Document Title		Addition of DC Power Input Adapter – 28-volt Power Supply				
Document #	Rev	Type	Reason	Recommendation	Original Release Date	
ZSB-012	A 2016/08/30	Service Bulletin	Performance Enhance	Optional	2013/05/14

## Addition of DC Power Input Adapter 28v Power Supply (Hydraulic RHGSE Only)

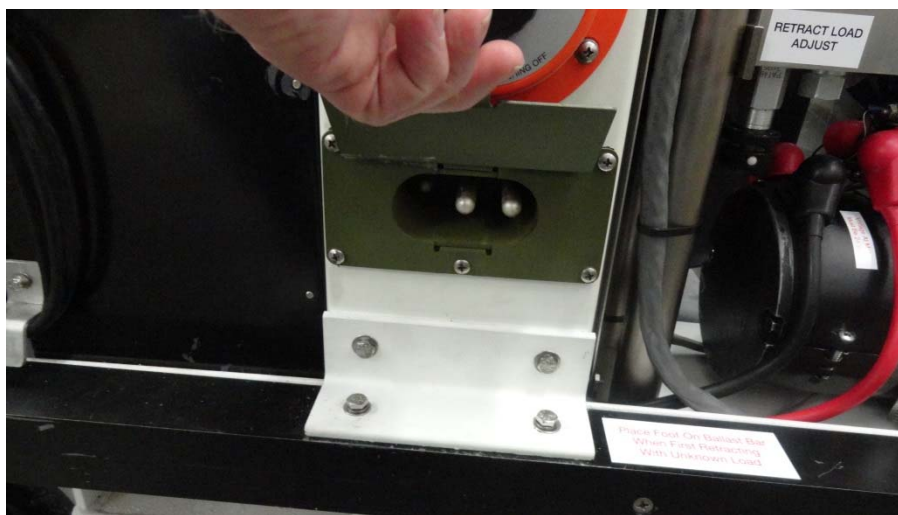
The modification is shown below:

To use the onboard batteries, the switch should be in position 1, and to use the external power receptacle the switch should be in position 2.

The switch also provides the capability to disconnect the batteries as a safety shut off.

The receptacle is a MS 3506-1 type and will mate with a MS25488 type plug.
